PE19-005

Campaign CB11-J-002 Cruise
Control Will Not Cancel

Campaign CB16-J-003
Important Safety Recall Stopper
Bracket Installation - 16V-797
(Transport Canada - 2016-545)

Issue Date: NOVEMBER 2016

Figure 2 –
 1. Stopper Bolt
 2. Stopper Plate

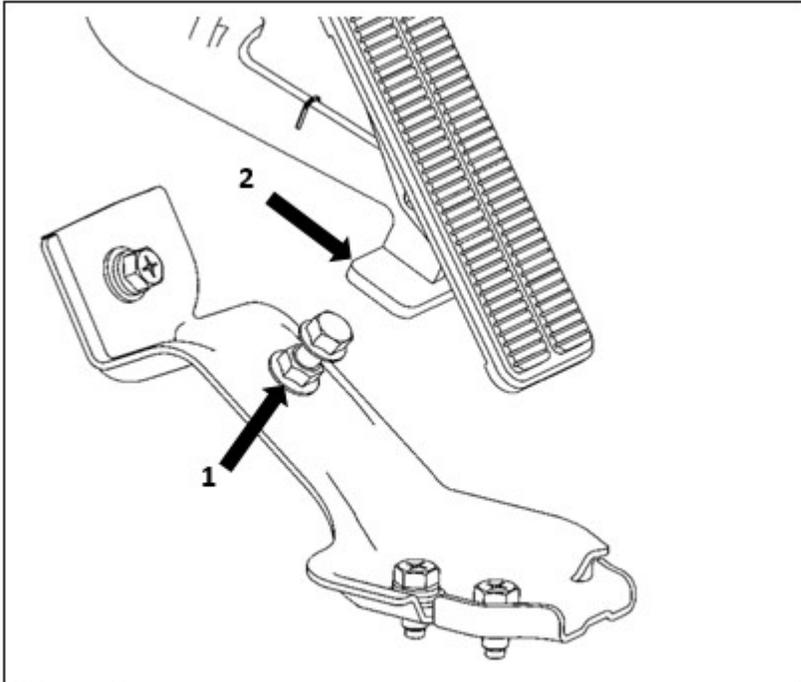
3. Remove the stopper bolt and nut, using 12mm wrench (see Figure 2). Discard both the old stopper bolt and nut.

Figure 4 – Stopper Bracket Alignment. Yellow indicates stopper bracket flange.

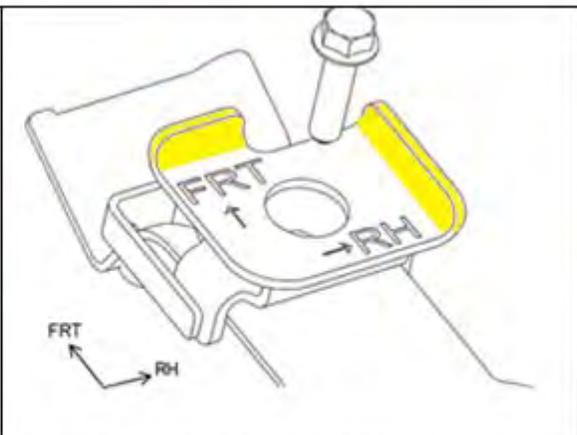
4. Temporarily install and hand tighten the new stopper bracket using the new bolt provided (see Figure 3). When tightened (even by hand), the head of the new mounting bolt should be below the flat surface of the new stopper bracket. Be sure the stopper bracket is aligned properly (see Figure 4).

Figure 5 – View From Right Side

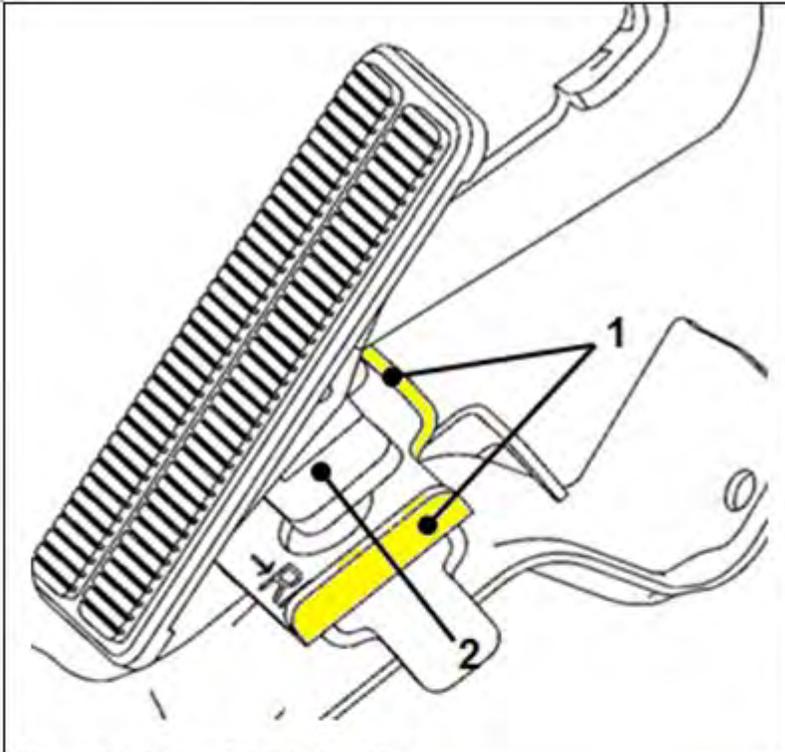
5. Depress the accelerator and ensure the stopper plate does not hit the flanged area of the stopper bracket (see Figures 5 and 6).

Figure 8 – View From Left Side. Yellow indicates stopper bracket flange.

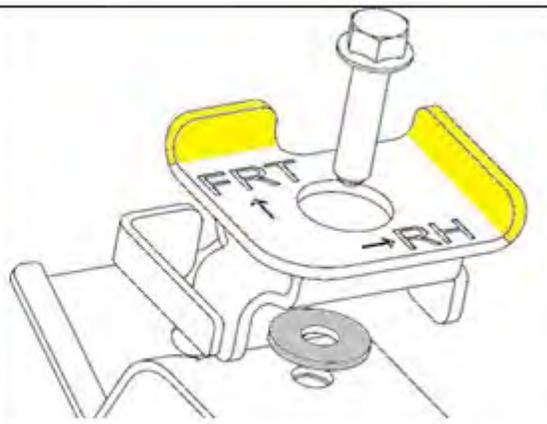
ii. If the washer does fit between these two parts, remove the stopper bracket and add the washer between the stopper bracket and the floor (see Figure 8), and reinstall. This will adjust the clearance. Check the clearance again by repeating Step 6 with the second washer and follow the results.

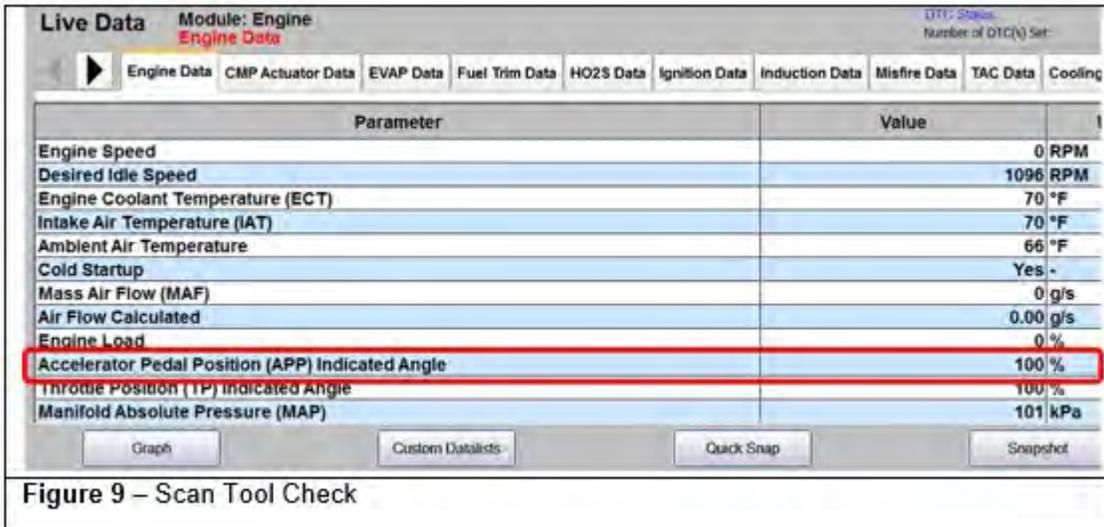
7. Connect IDSS, turn the key ON/engine OFF, and navigate to the engine control module data list to confirm “Accelerator Pedal Position (APP) Indicated Angle” parameter is at 100% during WOT (see Figure 9).

- a. If the parameter is at 100%, continue to Step 8.
- b. If the parameter is not at 100%, repeat Step 6 and recheck with IDSS. If the parameter continues to not be at 100%, and there is proper contact between the accelerator pedal and the stopper bracket, you may have incorrectly installed washers. Repeat Step 6 to confirm it was performed correctly. If these steps were performed correctly and the parameters still do not reach 100%, there is another problem with the vehicle. Follow the appropriate service manual for diagnosis.

Figure 4 – Stopper Bracket Alignment. Yellow indicates stopper bracket flange.

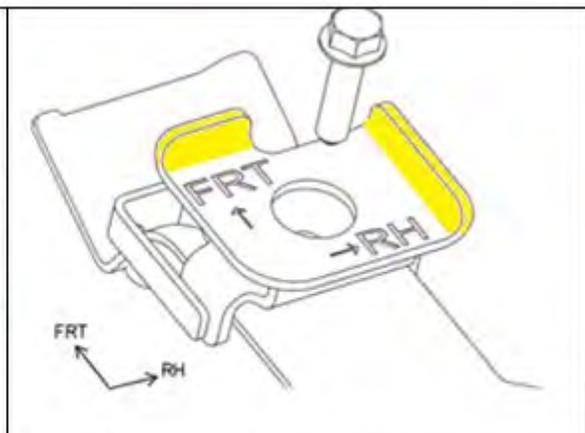
4. Temporarily install and hand tighten the new stopper bracket using the new bolt provided (see Figure 3). When tightened (even by hand), the head of the new mounting bolt should be below the flat surface of the new stopper bracket. Be sure the stopper bracket is aligned properly (see Figure 4).

Figure 5 – View From Right Side

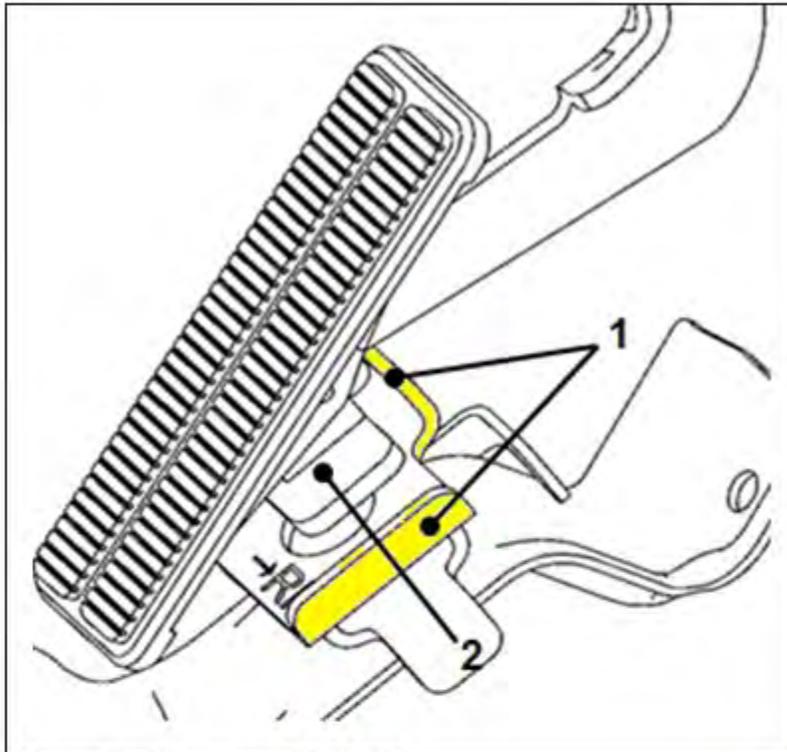
5. Depress the accelerator and ensure the stopper plate does not hit the flanged area of the stopper bracket (see Figures 5 and 6).

Figure 8 – View From Left Side. Yellow indicates stopper bracket flange.

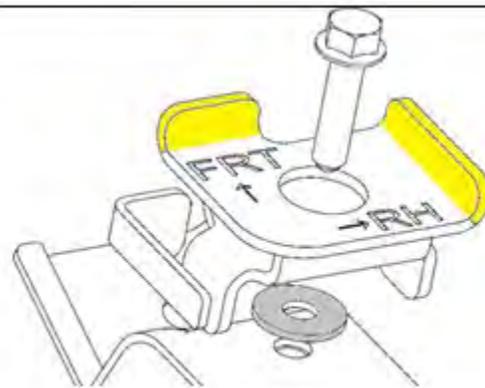
ii. If the washer does fit between these two parts, remove the stopper bracket and add the washer between the stopper bracket and the floor (see Figure 8), and reinstall. This will adjust the clearance. Check the clearance again by repeating Step 6 with the second washer and follow the results.

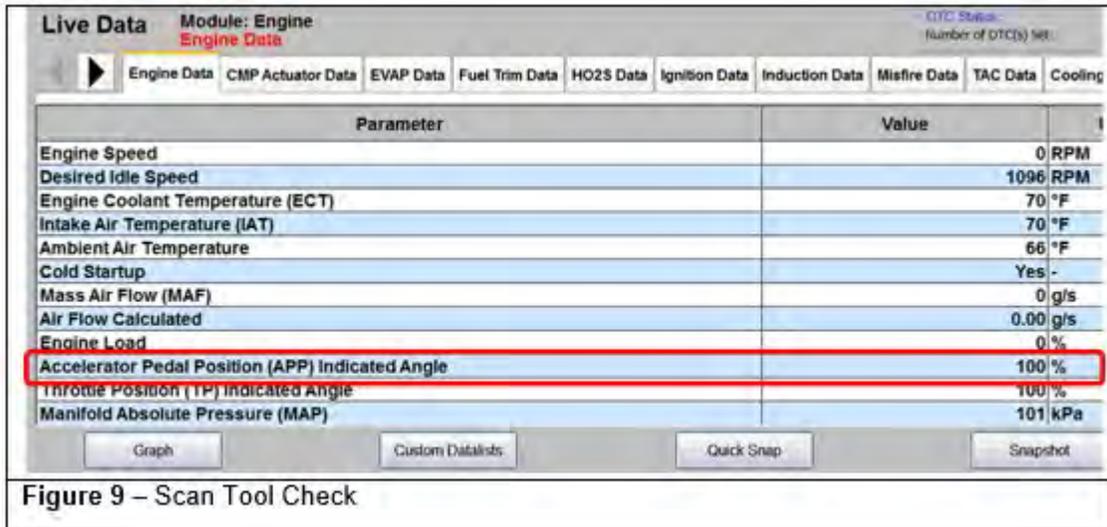
7. Connect IDSS, turn the key ON/engine OFF, and navigate to the engine control module data list to confirm “Accelerator Pedal Position (APP) Indicated Angle” parameter is at 100% during WOT (see Figure 9).

- a. If the parameter is at 100%, continue to Step 8.
- b. If the parameter is not at 100%, repeat Step 6 and recheck with IDSS. If the parameter continues to not be at 100%, and there is proper contact between the accelerator pedal and the stopper bracket, you may have incorrectly installed washers. Repeat Step 6 to confirm it was performed correctly. If these steps were performed correctly and the parameters still do not reach 100%, there is another problem with the vehicle. Follow the appropriate service manual for diagnosis.
